ADDENDUM NO. 4

Reference: Residential Halls Buildings 2 and 3
Weber State University – Ogden, Utah
DFCM Project No. 10176810 and 11008810

Subject: **Addendum No. 4**

FOOTING & FOUNDATION PLAN - AREA B

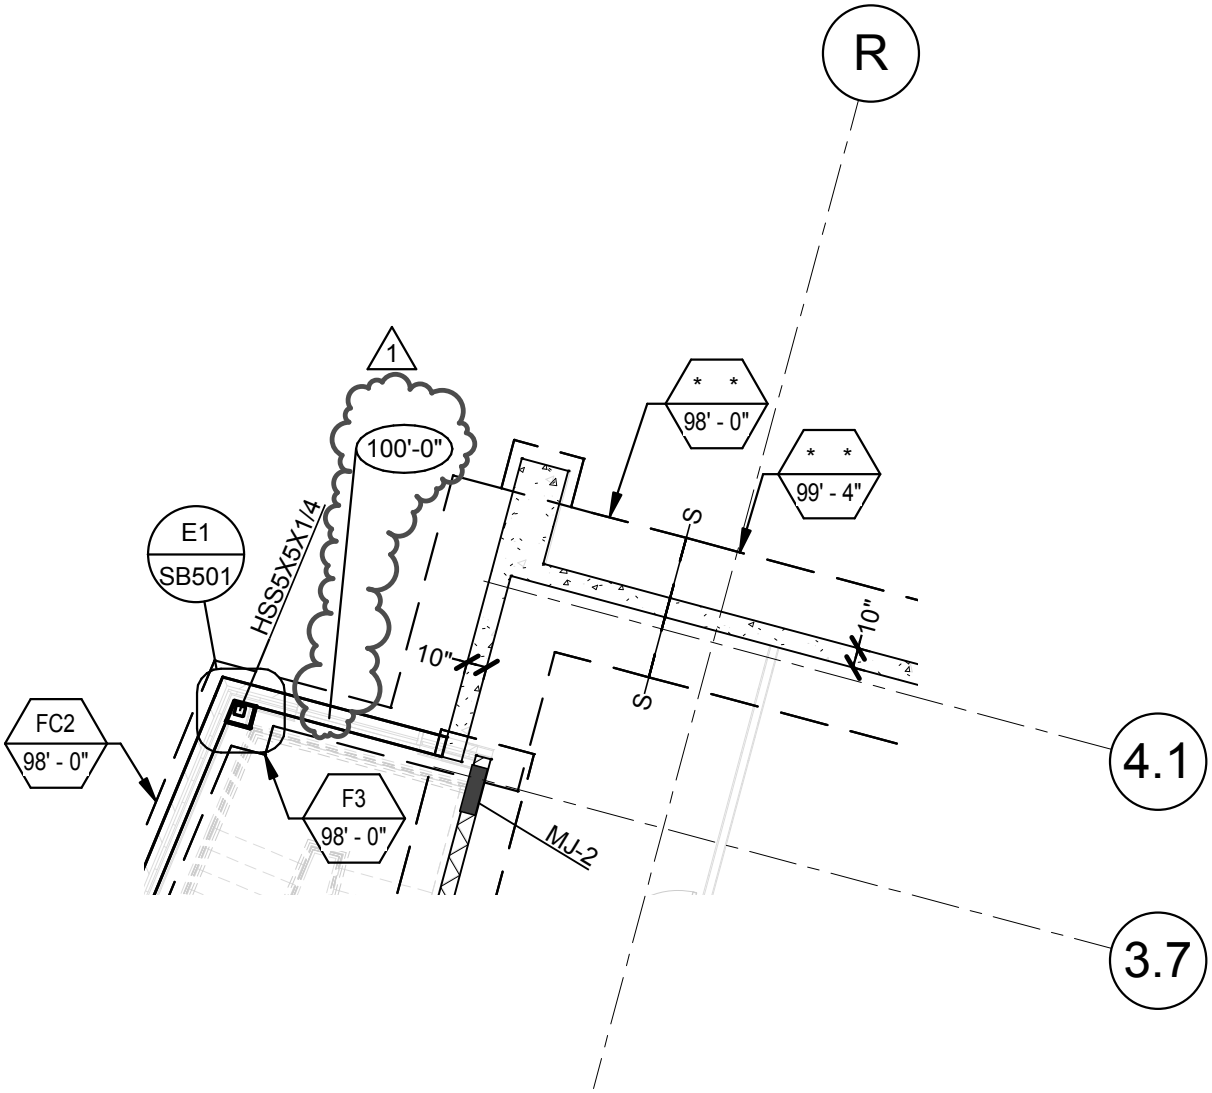
Sheet SB101B
-A top of foundation callout was added to the plan. Please see the attached sheet AD04_S02.

LOW ROOF FRAMING PLAN - AREA B

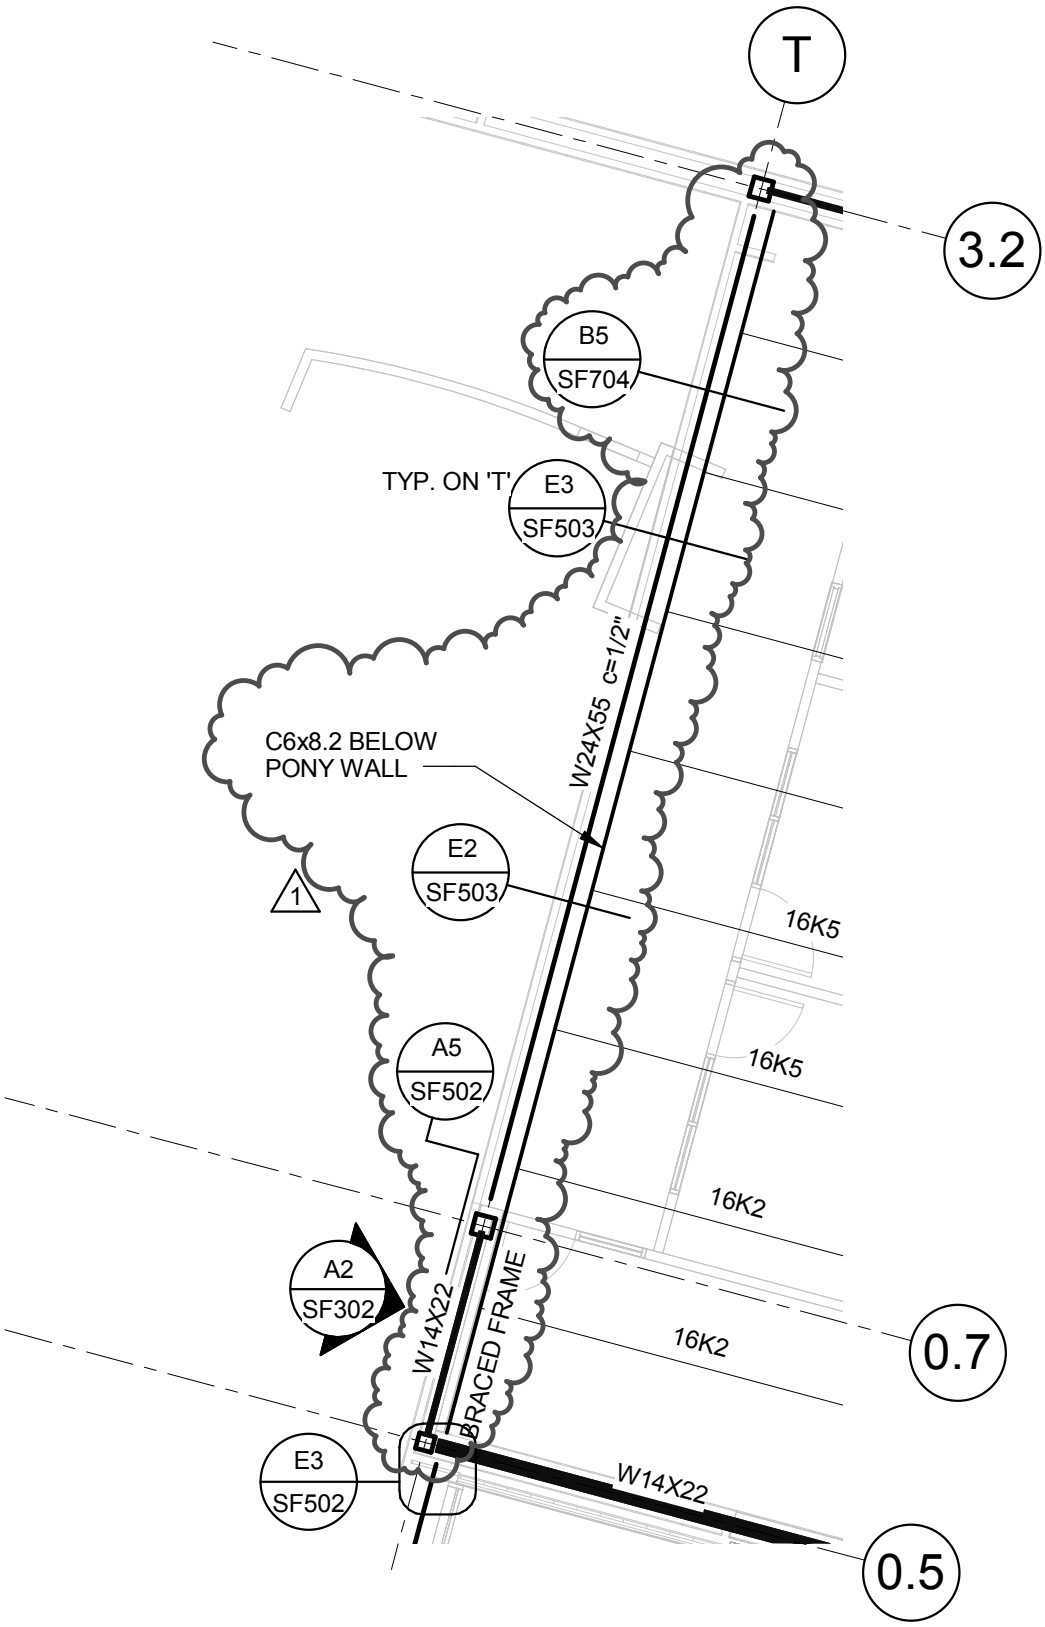
Sheet SF104B
-A steel channel was added to the roof to support the metal stud wall above. Please see the attached sheet AD04_S03.

SHEET NUMBER
AD04_S04

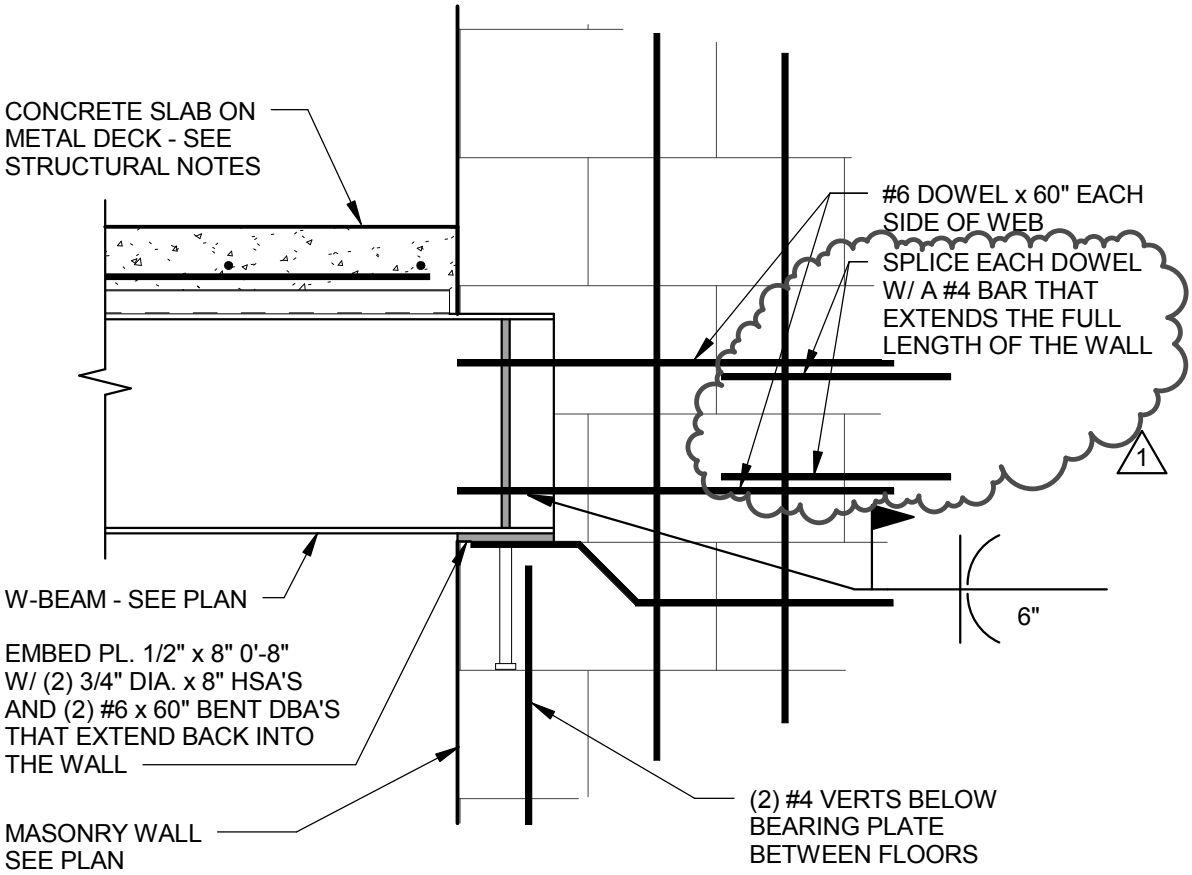
Sheet SF502
-Detail B5 has been revised to add additional bars to the floor level bond beam at this particular location. Please see the attached sheet AD04_S04.

SHEET NUMBER
AD04_S05

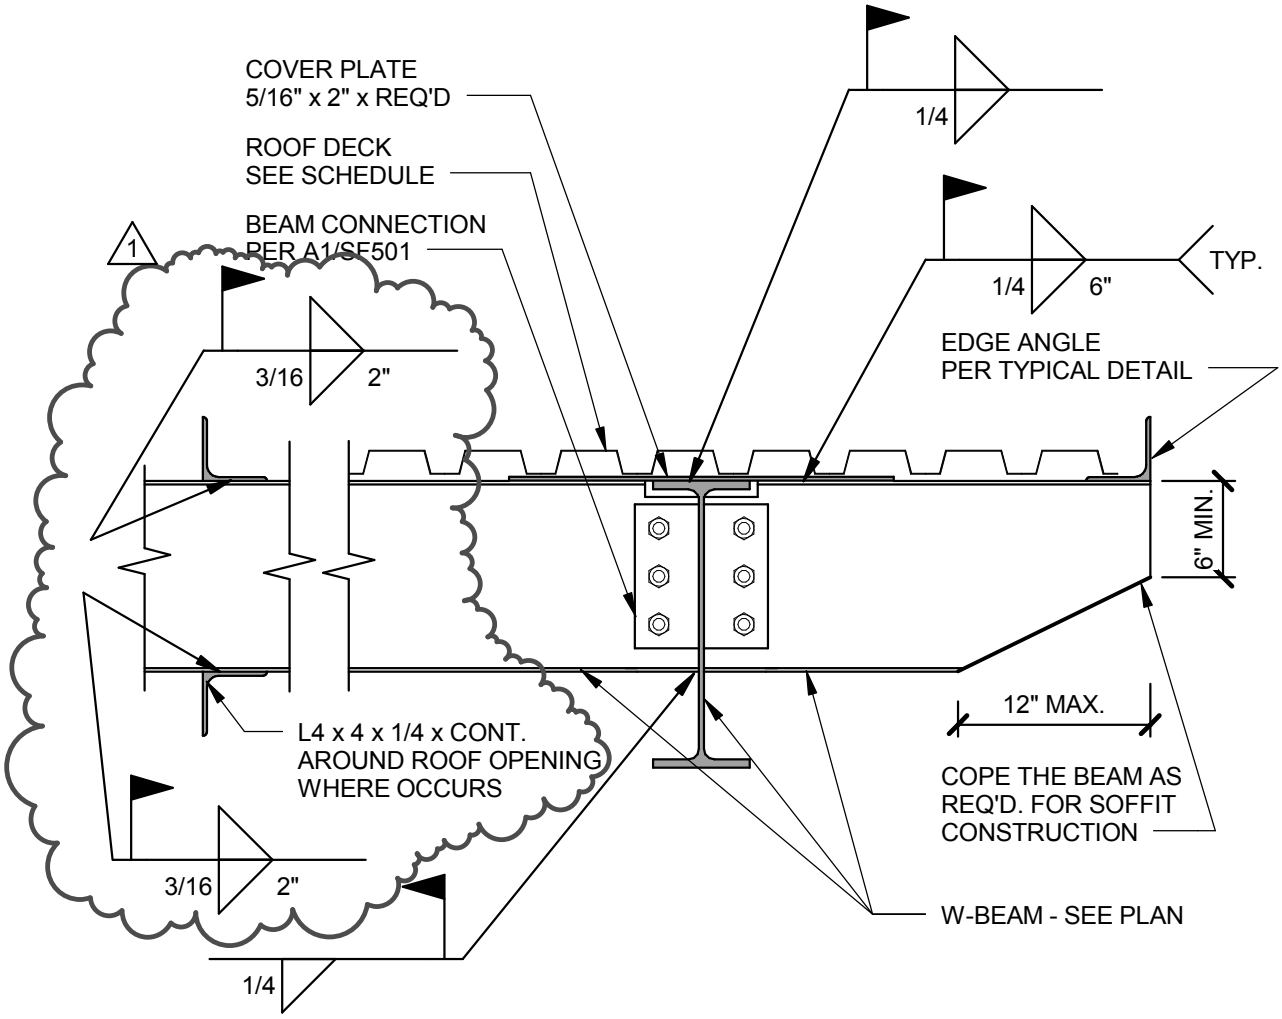
Sheet SF504
-Detail A3/SF504 has been revised. Please see the attached sheet AD04_S05.

SHEET NUMBER
AD04_S06

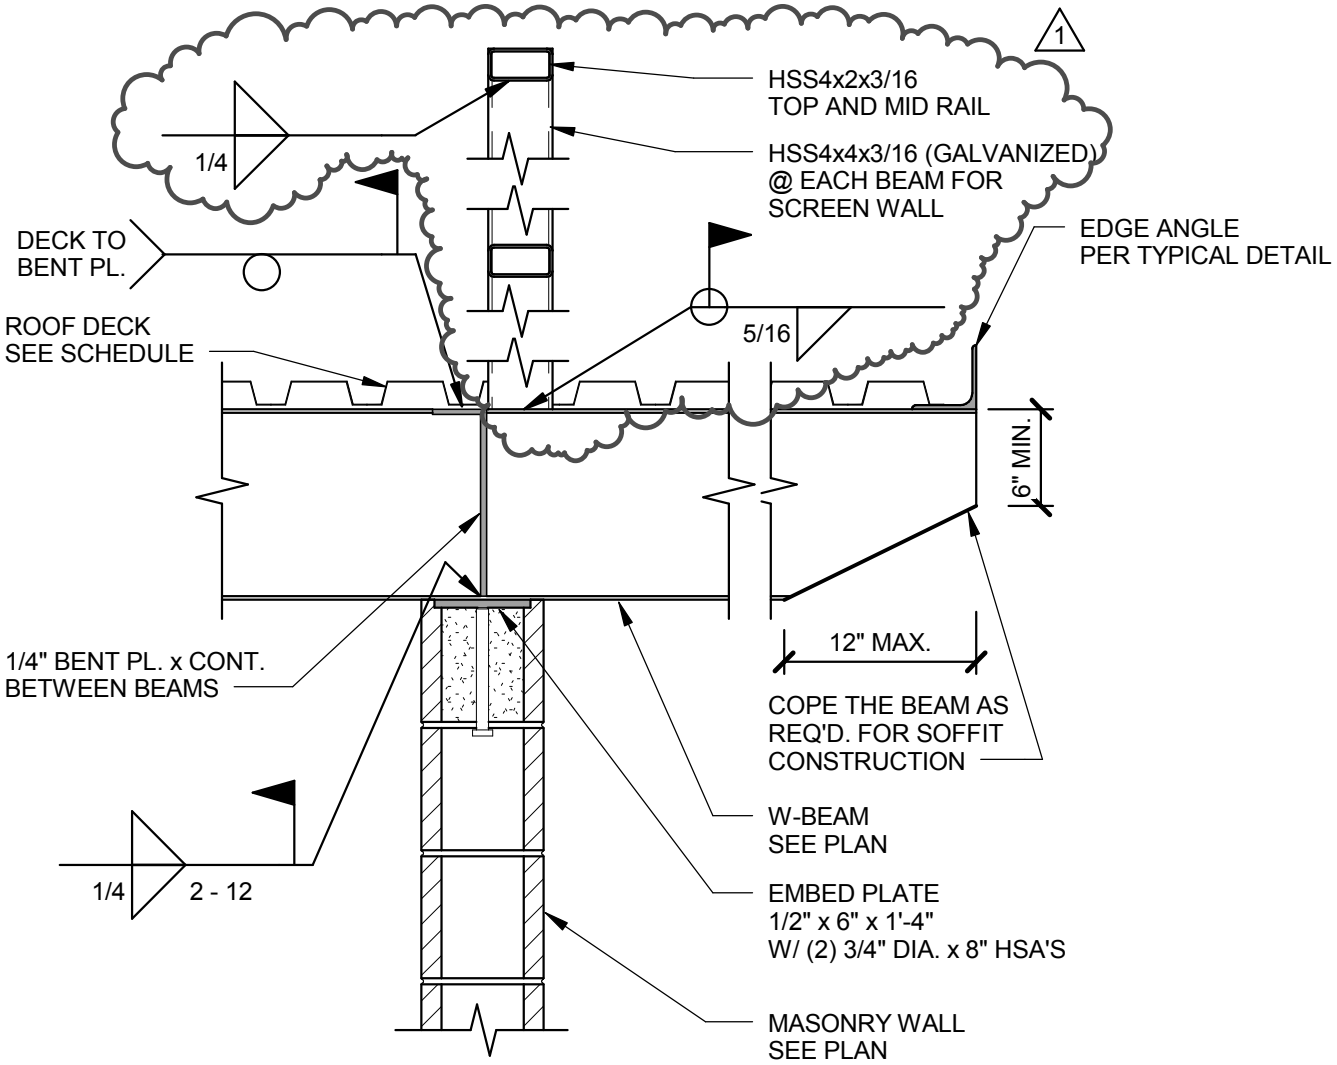
Sheet SF504
-Detail A4 has been revised. Please see the attached sheet AD04_S06.

WEST ELEVATION - POD B

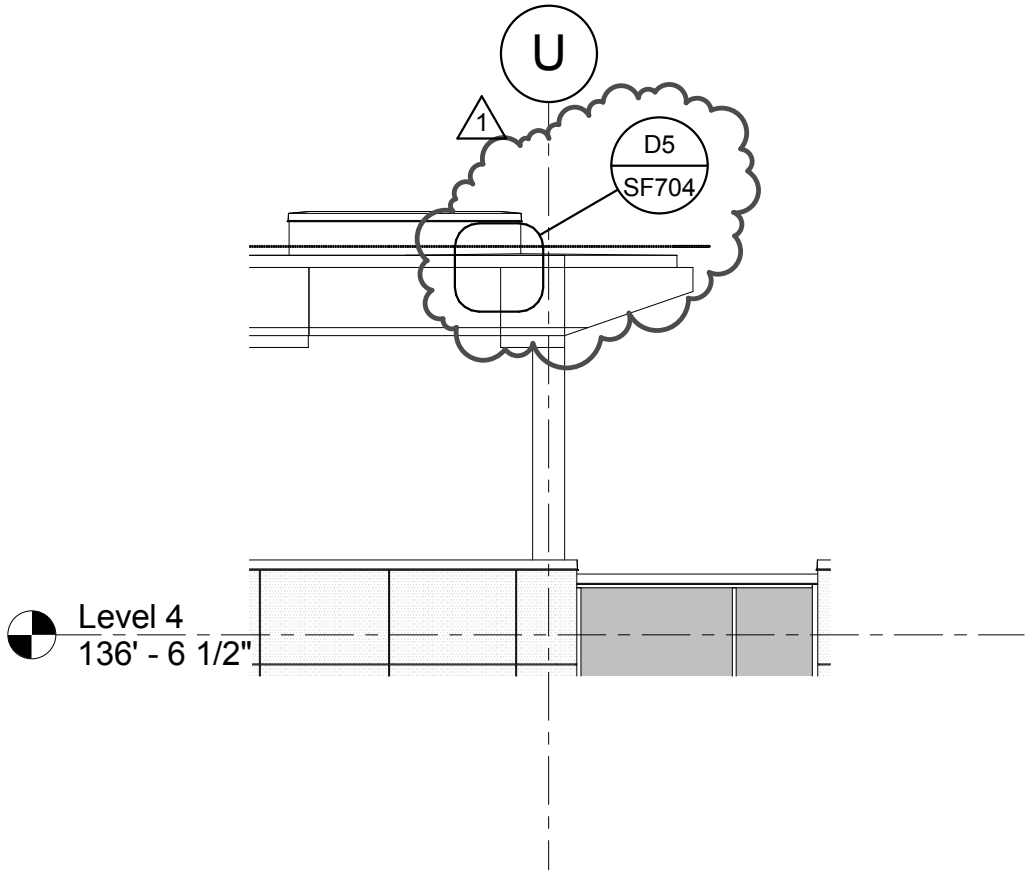
-A detail call out has been added to the elevation. Please see the attached sheet AD04_S07.

SHEET NUMBER
AD04_S08

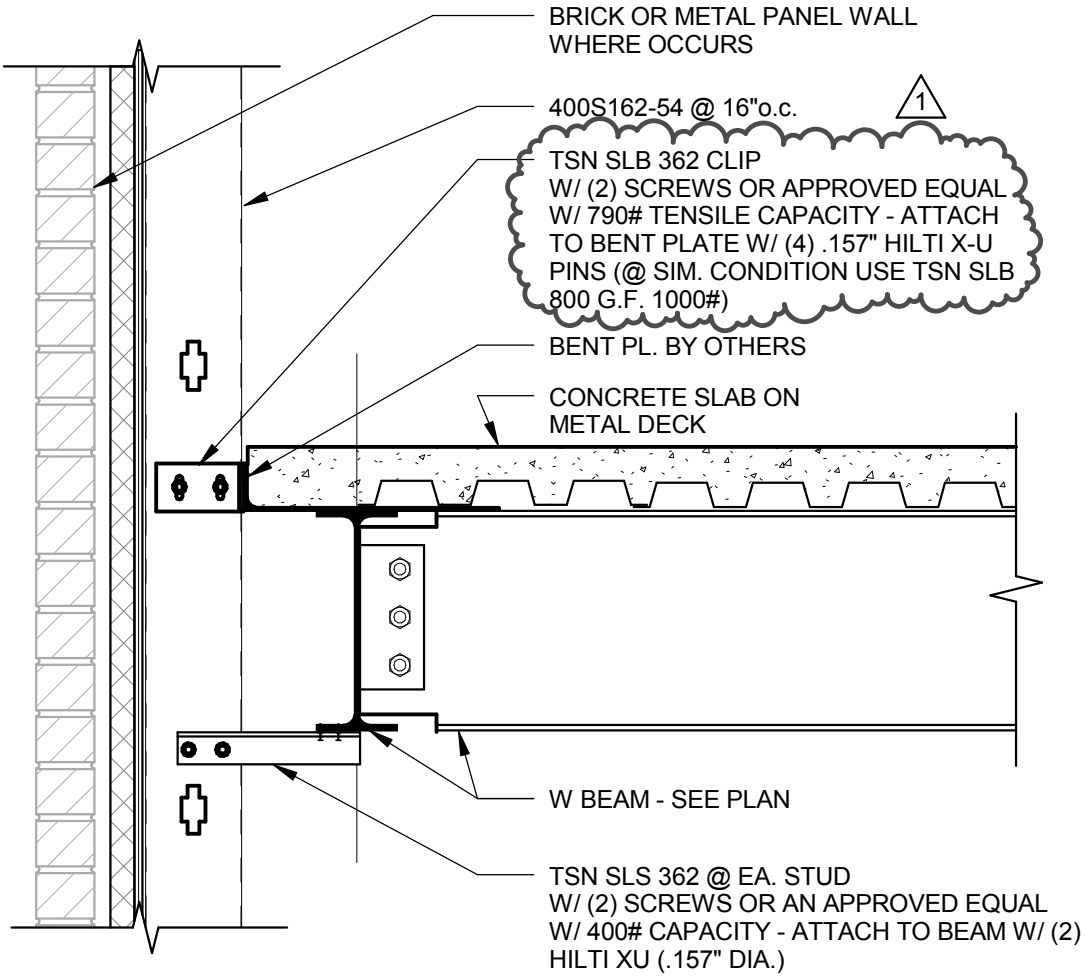
-Detail C1 has been revised. Please see the attached sheet AD04_S08.
